From: [James Quoyle](#)
To: "Adam Susko"
Cc: "DA Admin Mailbox"
Subject: RE: HMS 2363 RFI (1) - 6 Namona Street North Narrabeen / ARBORIST REPORT FOR NORTHER PARCEL
Date: Tuesday, 21 March 2023 2:35:00 PM
Attachments: [image005.png](#)
[image006.png](#)
[image008.png](#)
[image009.png](#)

Figure 48: Narrabeen North Primary School Library, Elevation and section 1974 (Binishell B) (Source: Binisystems.com).

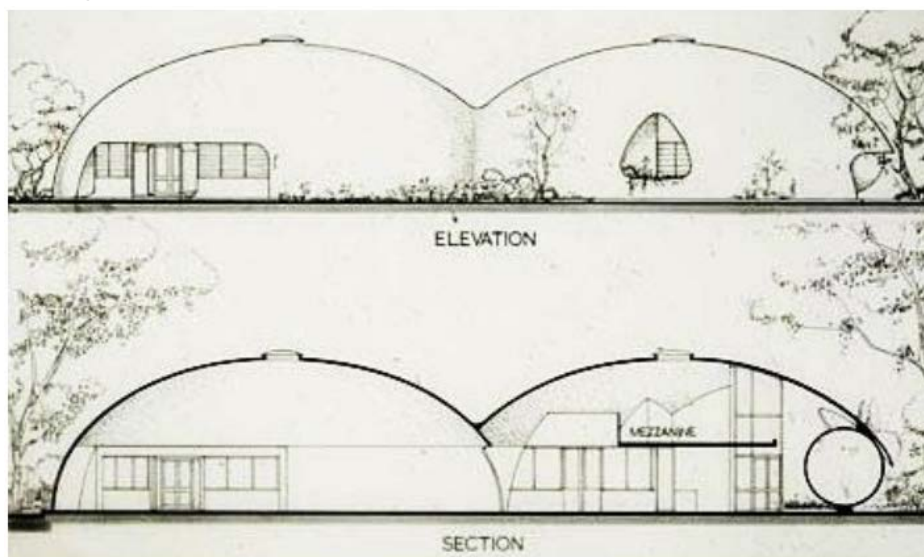
Attached is a drawing from the HIS of the domes showing the trees generally in the location of the existing trees:

Based on the information provided, the removal of the trees 55 and 58 is unlikely to be supported.
